Subject: **Response to Portion of NRC Request for Additional Information Letter No. 250 Related to ESBWR Design Certification Application – Site Characteristics - RAI Number 2.3-4 S04**

**Response to Portion of NRC Request for
Additional Information Letter No. 250
Related to ESBWR Design Certification Application
Site Characteristics**

RAI Number 2.3-4 S04¹

Figure 2.3-4(1) Typical Sketch of Roof Drain

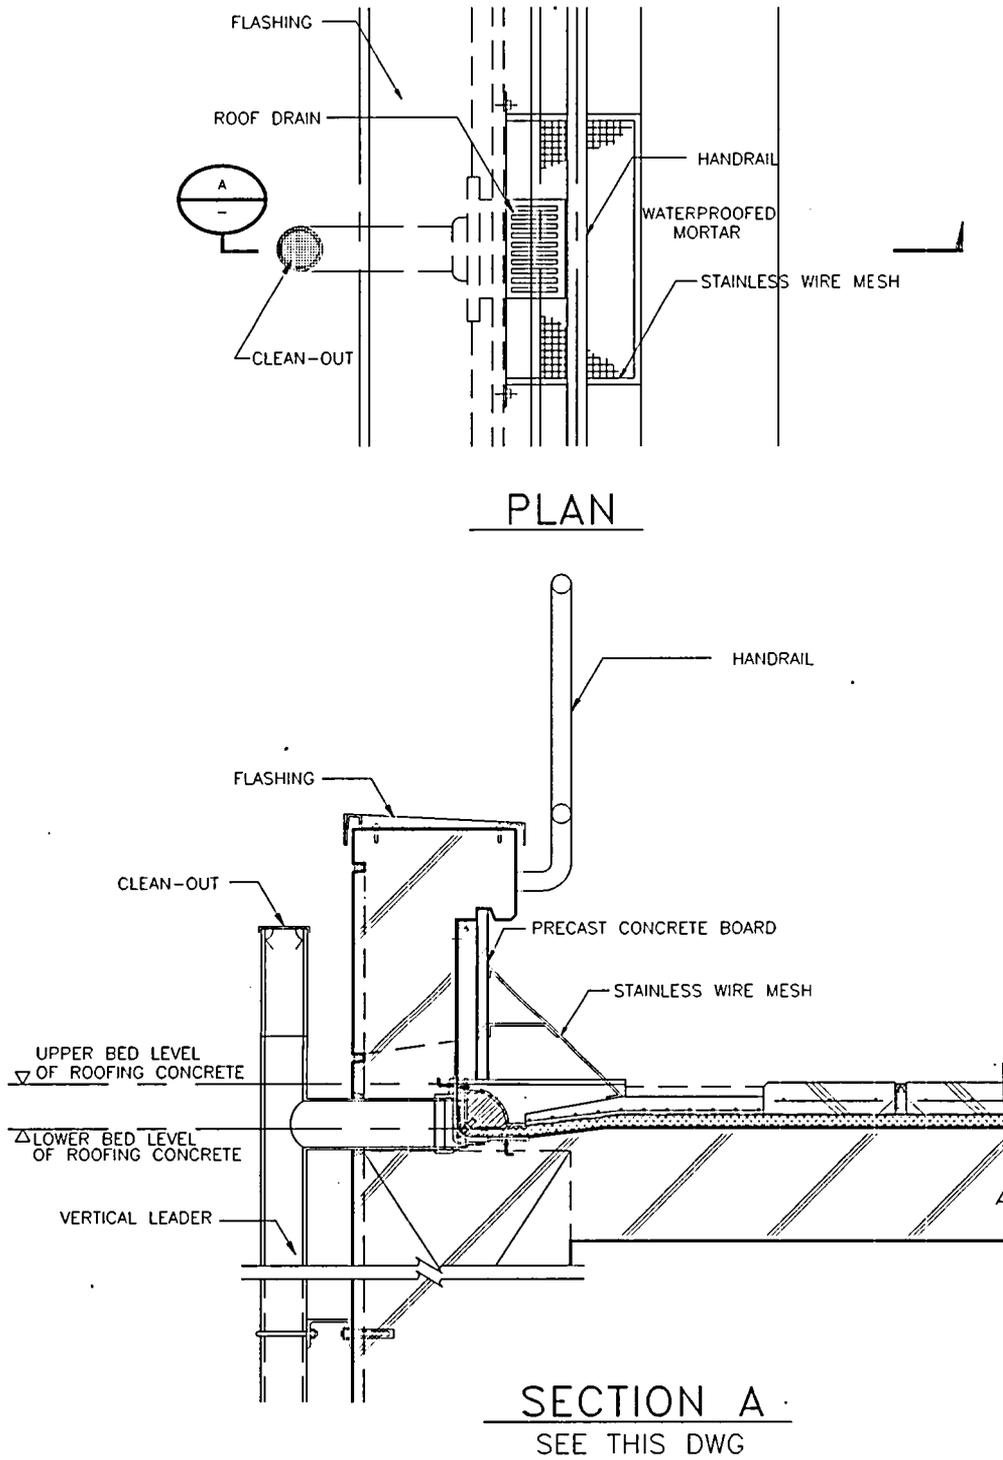
Footnote 5 to DCD Tier 2 Table 2.0-1 states that the roof scuppers and drains are designed independently to limit water accumulation on the roof to no more than 100 mm (4 in) during PMWP conditions. Please provide details of the design of the roof scuppers and drains demonstrating that an antecedent 100-year recurrence interval ground level snow pack of 2394 Pa (50 lbf/ft²) will not clog both the roof scuppers and drains and prevent no more than 100 mm (4 in) of water accumulating on the roof.

In the ESBWR Standard Plant, roofs are provided with two independent drainage systems. The roof drains form the primary drainage system and the scuppers form the secondary drainage system. As required by the International Plumbing Code (invoked by IBC-2003) and ASCE 7-02, only the blockage of the primary system is postulated when designing the secondary system and for calculating the rain load on the roof.

Figures 2.3-4(1) and (2) show typical sketches of the roof drain and overflow scupper. The design of the roof scuppers and drains follows ASCE 7-02. The elevation of the overflow scupper is set such that the average water depth does not exceed 100 mm (4 in.) in case the roof drains are clogged by snow, ice, or other obstructions.
